HUMAN FACTORS EVALUATION OF THE
STANDARD NUCLEAR UNIT POWER PLANT SYSTEM
(SNUPPS)

Nuclear Projects, Inc.
5 Choke Cherry Road
Rockville, Md. 20850

Essex Corporation
333 North Fairfax Street
Alexandria, Virginia 22314

From September 1980 to February 1981, the Essex Corporation of Alexandria, Virginia performed a human engineering evaluation of the Standard Nuclear Unit Power Plant System (SNUPPS) for Nuclear Projects, Incorporated. Data were collected from two sources: the Westinghouse simulator at Zion; and the as-built control boards at the Callaway site. The evaluation employed human engineering assessment techniques developed by Essex Corporation specifically for power plant control room design reviews. These techniques were developed while writing NUREG/CR-1580 for the NRC and subsequently were refined during control room reviews for other utilities.

FIGURE 1. Reactor Trip : Source Range High Neutron Flux

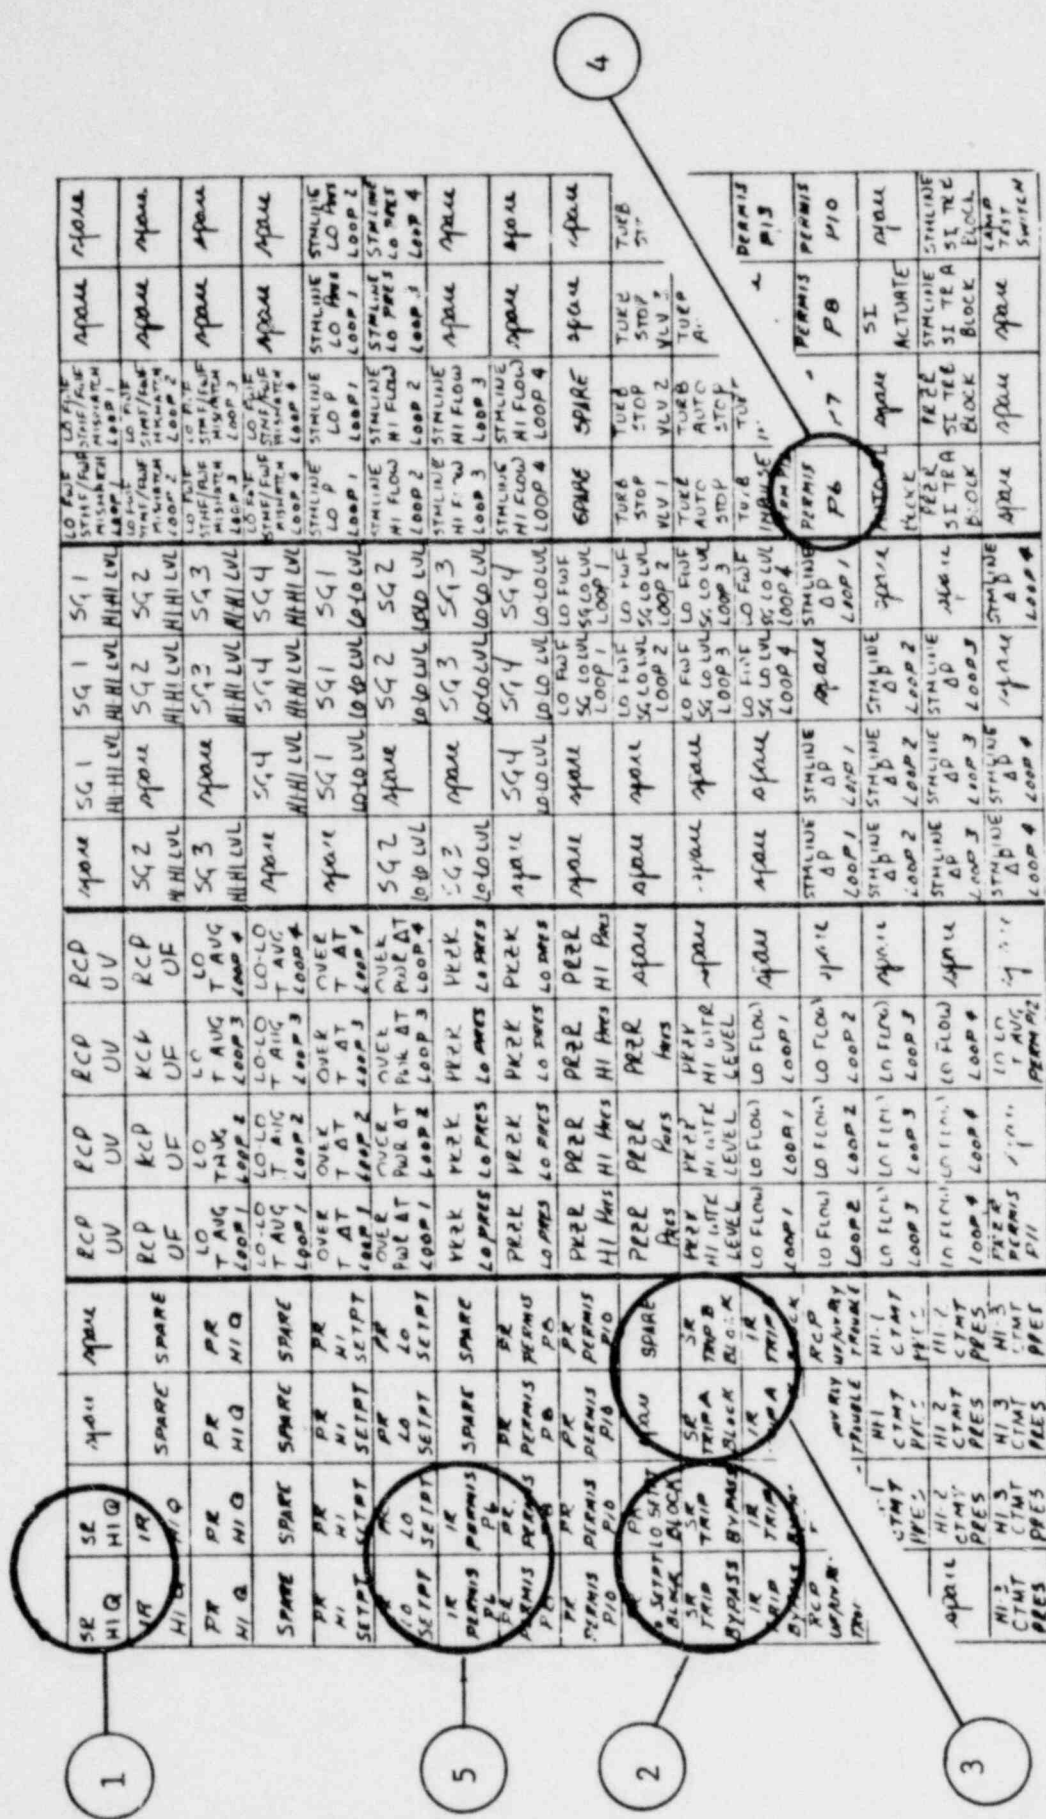
An example of how the operator would need to search the panel in order to gain information follows. The reactor trip, Source Range High Neutron Flux, is the "first" trip visually encountered on the panel. The two trip channels are located at position ① on Figure 1. The trip channels can be bypassed; bypass indicators are located at position ②. The trip can be blocked, position ③, if permissive P6 ④ is satisfied. Permissive P6 is satisfied when one of the two neutron flux detectors (intermediate range) is above the setpoint, position ⑤. As Figure 1 indicates, the operator must integrate information scattered all over the board. This causes a tremendous load on his short-term memory and information processing ability. The operator cannot use any techniques of pattern recognition.

FIGURE 2. TYPICAL MIMIC - POTENTIAL FORMAT

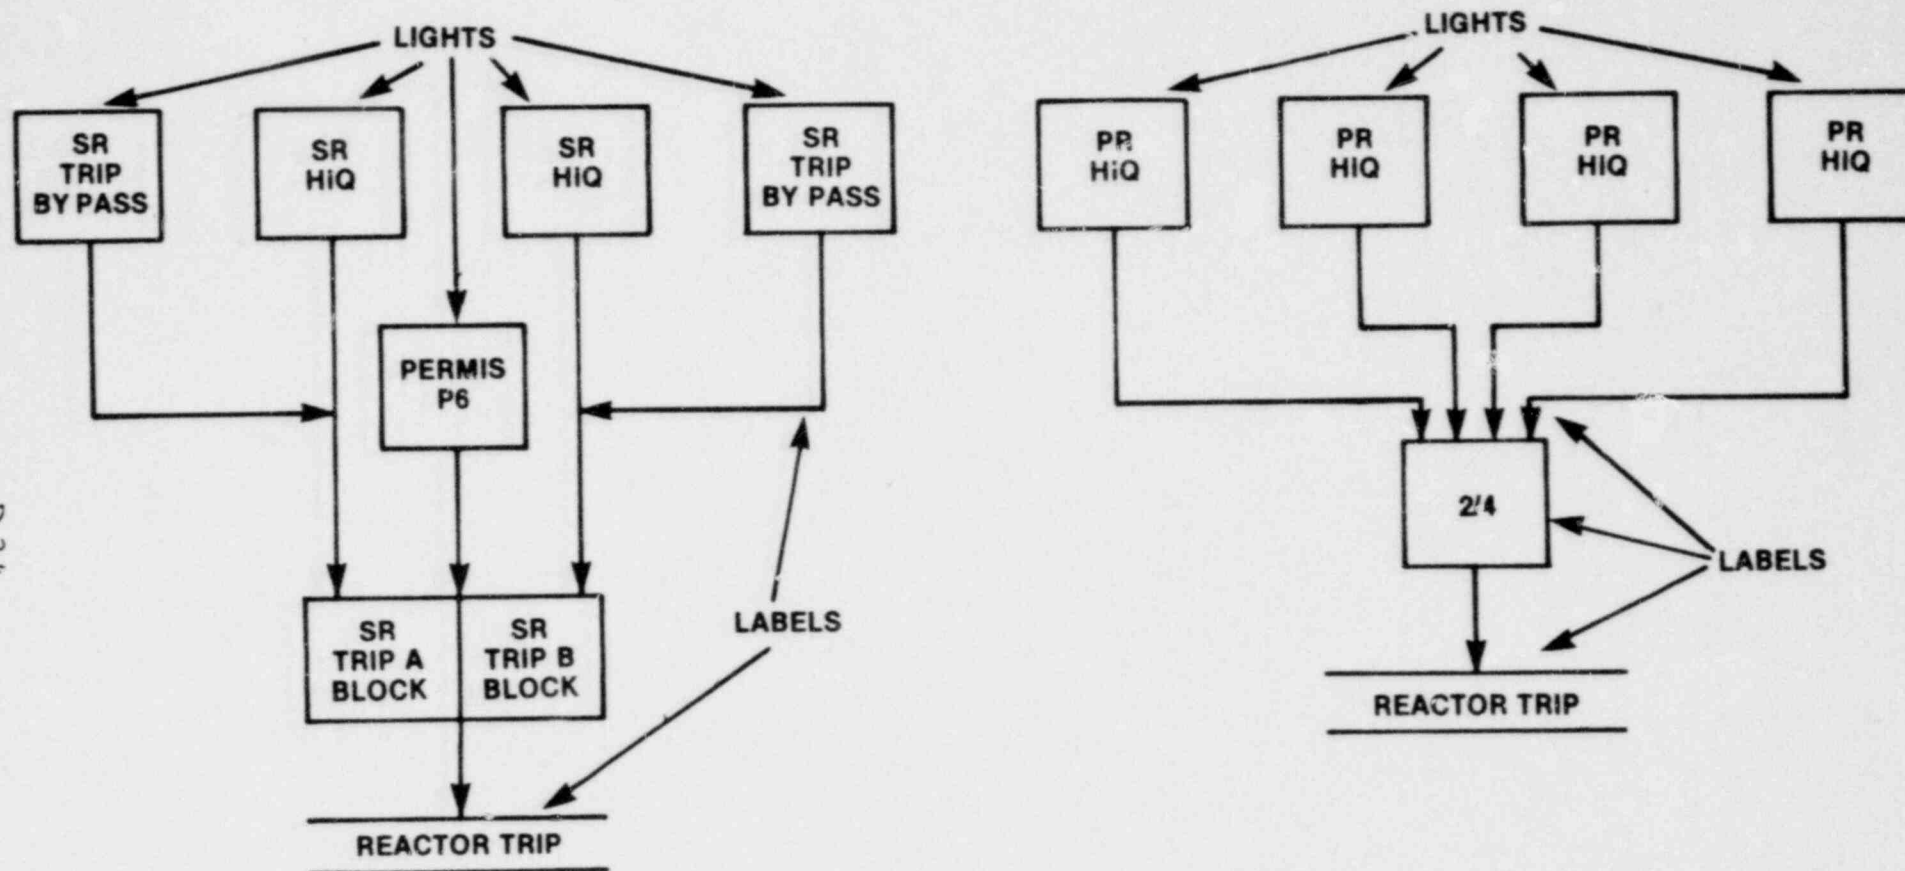
There appear to be no effective means for relocating windows that would measurably improve the utility of the status board. The board represents logic flows. Therefore, the most effective way to provide this information would be in a mimic. The permissives could be grouped in a status panel and the trip logic could be diagrammed in flow lines. Figures 2 and 3 illustrate how this could be done.

FIGURE 1: DEMARCATION ZONES FOR RL002, SNUPPS

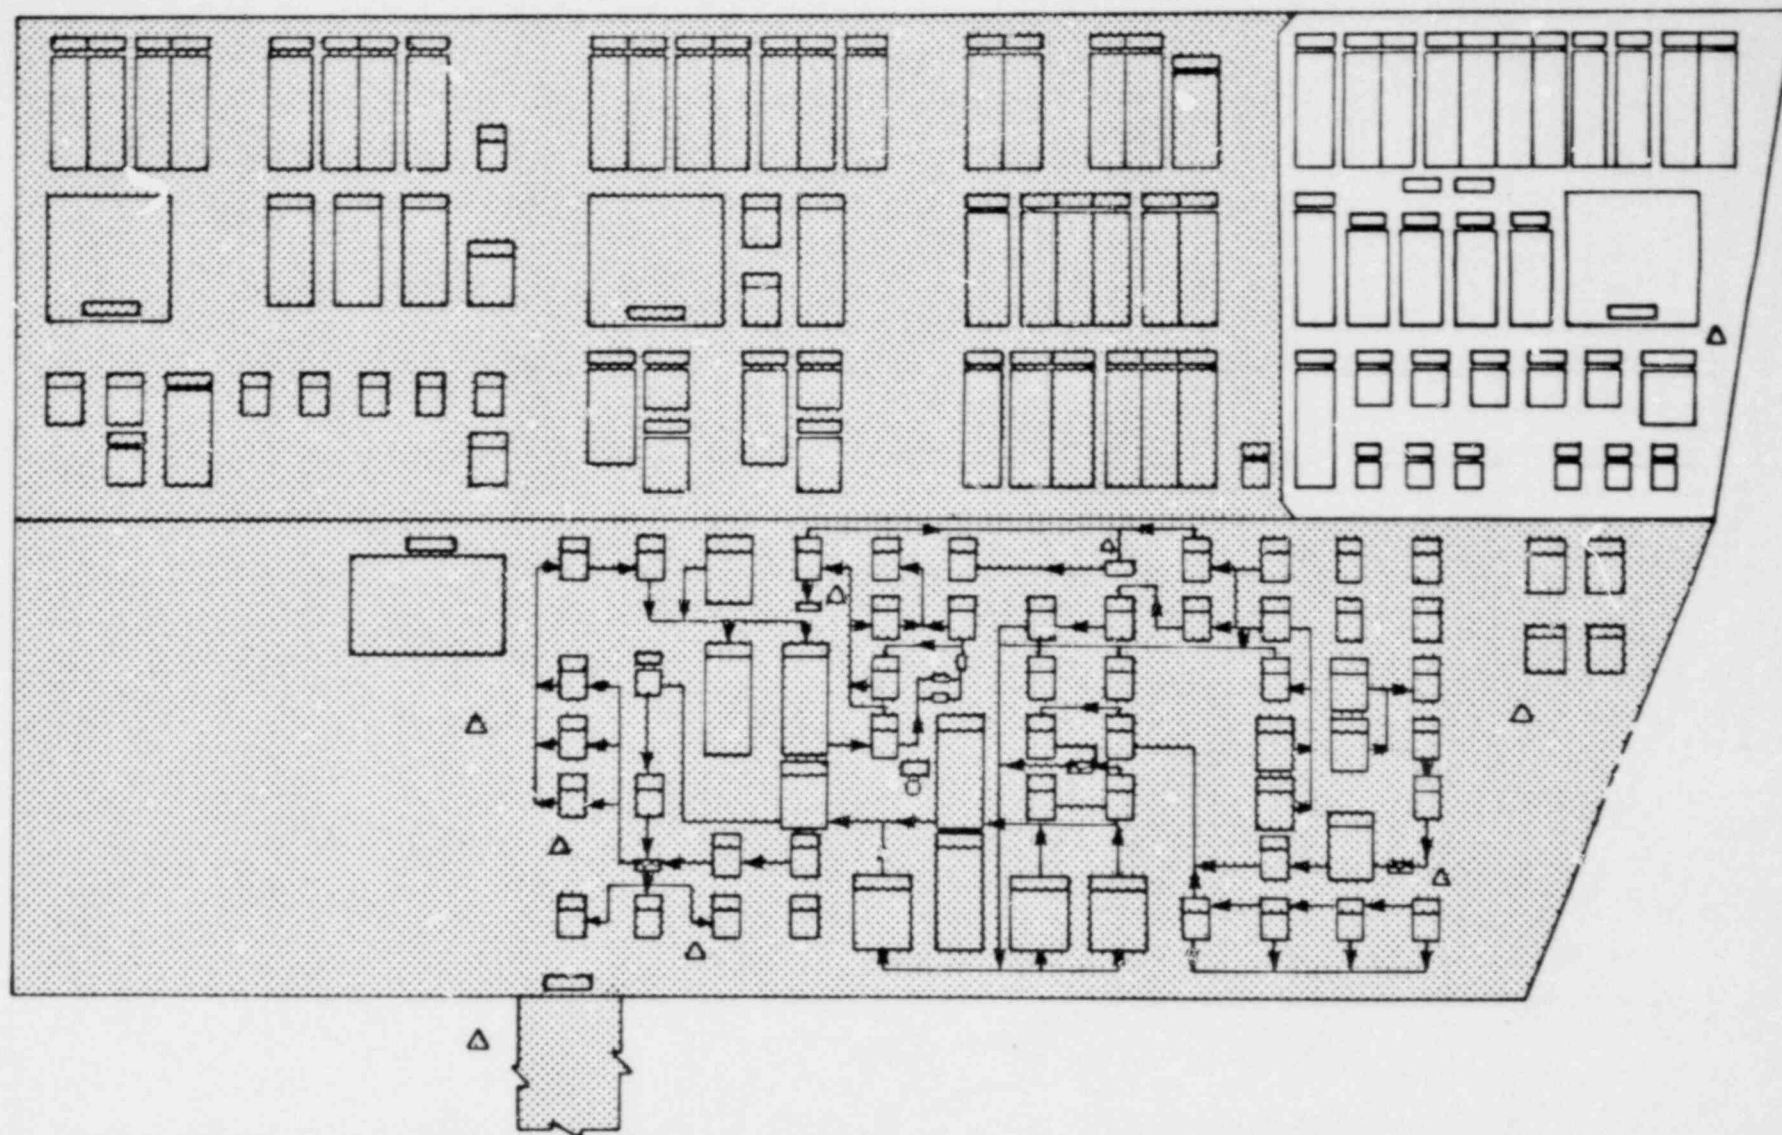
The following figures represent the minimum areas that should be demarcated either by lines or background coloring. These areas should include summary labels. For consistency, other panel areas should also be labeled with summary labels. This will significantly reduce visual search time and memory load.
